Office Action Summary	Application No. 10/810,115	Applicant(s) ANDRASIC ET AL.	
	Examiner Patricia L. Engle	Art Unit 3612

DETAILED ACTION

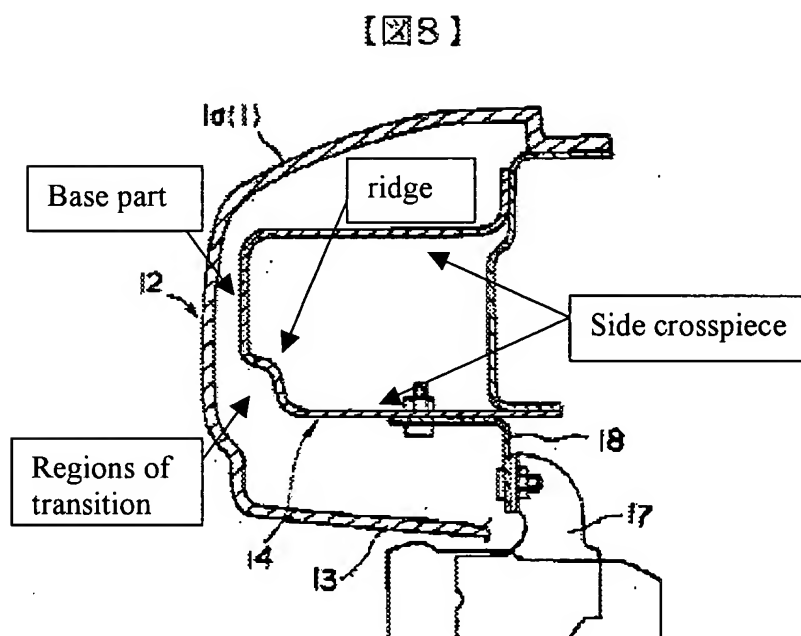
4. Claims 1-9 are rejected under 35 U.S.C. 102(b) as being anticipated by JP11-34770.

Regarding claims 1 and 9, JP 11-34770 discloses a bumper for a motor vehicle (1), comprising: an outer bumper (12) part; and an inner bumper part (14) including a base part (see below) and at least one side crosspiece (see below- this limitation is met by the lower crosspiece) positioned at an angle to the base part, regions of a transition (see below) from the base part to

the side crosspiece configured so that deformation of the inner bumper part occurs in a predetermined direction (the corner of the ridge is a stress raiser with the highest bending moment arm and therefore would be the point of failure in response to a force, since the failure location would be known then the direction of failure would also be known) in response to a force applied to the bumper, the region of the transition from the base part to the side crosspiece including a ridge pointing in a desired direction of deformation.

Regarding claim 2, JP11-34770 discloses the bumper according to claim 1, wherein the ridge includes a triangular cross-section (see above).

Regarding claim 3, JP11-34770 discloses the bumper according to claim 1, wherein the inner bumper part includes two side crosspieces (see above).
